RAJASTHAN METRO RAIL CORPORATION					ADDENDUM -04	
Name of Work: ICB-2C-03: Design and Construction of Elevated Viaduct and 11 Elevated Stations (including Architectural finishing) viz. B2 Bypass Circle, Durgapura, Gopalpura, Gandhinagar, Nehru Place, Ram Bagh Circle, Narayan Circle, SMS Hospital, Ashok Marg, Government Hostel and Khasa Kothi (Phase-II), Architectural Finishing works of 10 Stations viz. Prahladpura, Manpura, Bilwa Kalan, Bilwa, Goner Mod, Sitapura, JECC, Kumbha Marg, Haldighati Gate and Pinjrapole Gaushala; modification of part operational corridor of Phase-1 and constructing Khasa Kothi (Phase-1) station under Jaipur Metro Phase- II MRTS						
Addendum- 04 Summary Sheet

Invitation for Bids

Reply to Pre-Bid Queries

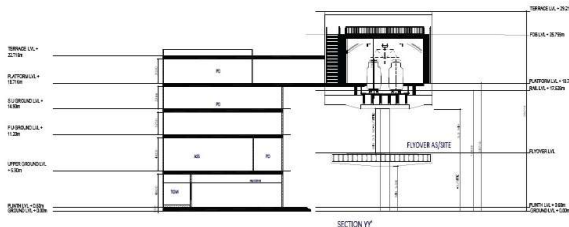
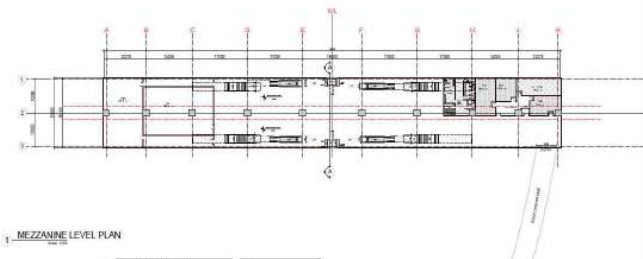
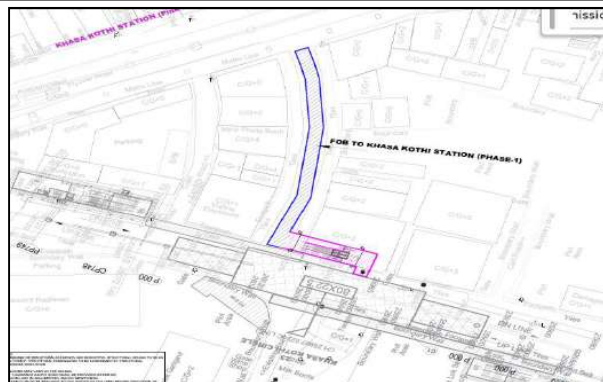
46	Khasa Khoti Halt Station		 MEZZANINE LEVEL PLAN	Kindly confirm the type of Khasa Khoti Halt Station of Phase 1 and is it totally new station to be constructed. Also, the drawings shows the total length of Station to be constructed is 140 metres without any future provision. Please confirm.	No change in bid condition.
47	FOB to Khasa Khoti Halt Station	FOB Drawing - Site Plan		Kindly mention the width and total length of FOB to Khasa Khoti Halt Station	No change in bid condition.

Name of the Work:		Project Name: ICB:2C-03; Design and Construction of Elevated Viaduct and 11 Elevated Stations (including Architectural finishing) viz. B2 Bypass Circle, Durgapura, Gopalpura, Gandhinagar, Nehru Place, Ram Bagh Circle, Narayan Circle, SMS Hospital, Ashok Marg, Government Hostel and Khasa Kothi (Phase-II), Architectural Finishing works of 10 Stations viz. Prahladpura, Manpura, Bilwa Kalan, Bilwa, Goner Mod, Sitapura, JECC, Kumbha Marg, Haldighati Gate and Pinjrapole Gaushala; modification of part operational corridor of Phase-1 and constructing Khasa Kothi (Phase-1) station under Jaipur Metro Phase- II MRTS			
Bidder-G (1st Set)					
Sr No	Title	Volume, Clause, Page no.	Existing Clause / Condition in Tender	Clarification / Amendment Sought	JMRC's Reply
			 Art	width is indicated as 15.03 meters, which appears to be contradictory. Therefore, we request the authority to kindly clarify the correct width of Mentioned Stations to ensure uniformity in design considerations.

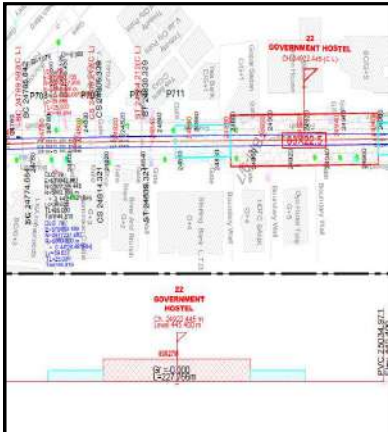
38	Provision of supervision, emergency vehicles and inspection vehicles	Part-2: Employer’s Requirement Pg 73 Appendix-16	The contractor will provide following vehicles under this contract in addition to the supervision of emergency vehicles and inspection vehicles mentioned under other sections of Employer’s Requirements. (i) 1 nos. of air-conditioned vehicle (Scorpio or equivalent E-vehicle) with limit of 3000Km per month for engineer. (ii) 06 nos. of air-conditioned vehicle (Bolero or equivalent E-vehicle) with limit of 3000Km per month for Engineer. (iii) 1 nos. of air-conditioned vehicle (Scorpio or equivalent E-vehicle) with limit of 3000Km per month for Employer. (iv) 06 nos. of air-conditioned vehicle (Bolero or equivalent E-vehicle) with limit of 3000Km per month for Employer.	As per the mentioned clause, it is understood that the successful bidder will provide 14 number of Vehicles for the use of Employer which is very much high as compared to Client facilities to other metro projects. We request you decrease this requirement of vehicles to a suitable number (2 to 3 vehicles) which will reduce the overhead burden of Contractor for more competitve bid.	No change in bid condition.

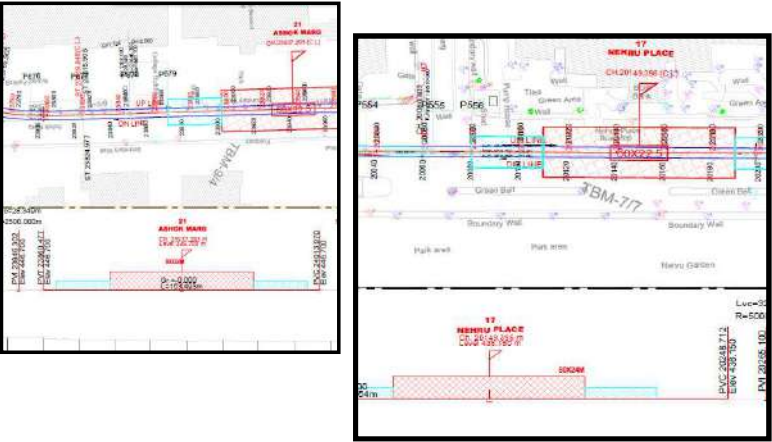
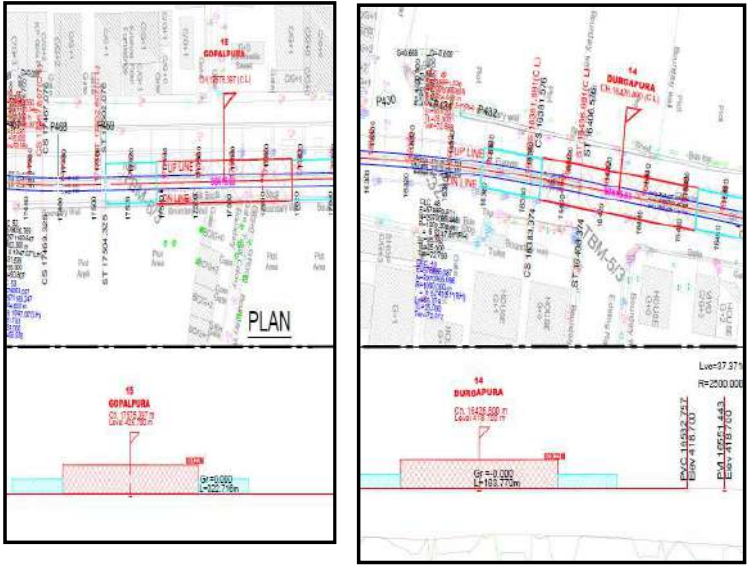
45	Width of Stations - Type 6 - Durgapura Gopalpura			In Drawings Part of the tender document, the General Arrangement Drawing (GAD) for Durgapura, Gopalpura Station - Type 6 shows the station width as 22 meters, whereas in attached table from Tender drawings- Type 6, the width is indicated as 15.03 meters, which appears to be contradictory. Therefore, we request the authority	Tender Architectural Drawings are to be referred for Station Dimensions.

Name of the Work:		Project Name: ICB:2C-03; Design and Construction of Elevated Viaduct and 11 Elevated Stations (including Architectural finishing) viz. B2 Bypass Circle, Durgapura, Gopalpura, Gandhinagar, Nehru Place, Ram Bagh Circle, Narayan Circle, SMS Hospital, Ashok Marg, Government Hostel and Khasa Kothi (Phase-II), Architectural Finishing works of 10 Stations viz. Prahladpura, Manpura, Bilwa Kalan, Bilwa, Goner Mod, Sitapura, JECC, Kumbha Marg, Haldighati Gate and Pinjrapole Gaushala; modification of part operational corridor of Phase-1 and constructing Khasa Kothi (Phase-1) station under Jaipur Metro Phase- II MRTS			
Bidder-G (2st Set)					
					Annexure A
Sr No	Title	Volume, Clause, Page no.	Existing Clause / Condition in Tender	Clarification / Amendment Sought	JMRC's Reply
44	Width of Stations - Type 3 - B2 Bypass Circle Nehru Place Ashok Marg			In Drawings Part of the tender document, the General Arrangement Drawing (GAD) for B2 Bypass, Nehru Place, Ashok Marg Station - Type 3 shows the station width as 24 meters, whereas in attached table from Tender drawings- Type 3, the width is indicated as 22.5 meters, which appears to be contradictory. Therefore, we request the authority to kindly clarify the correct width of mentioned Station to ensure uniformity in design considerations.	Tender Architectural Drawings are to be referred for Station Dimensions.
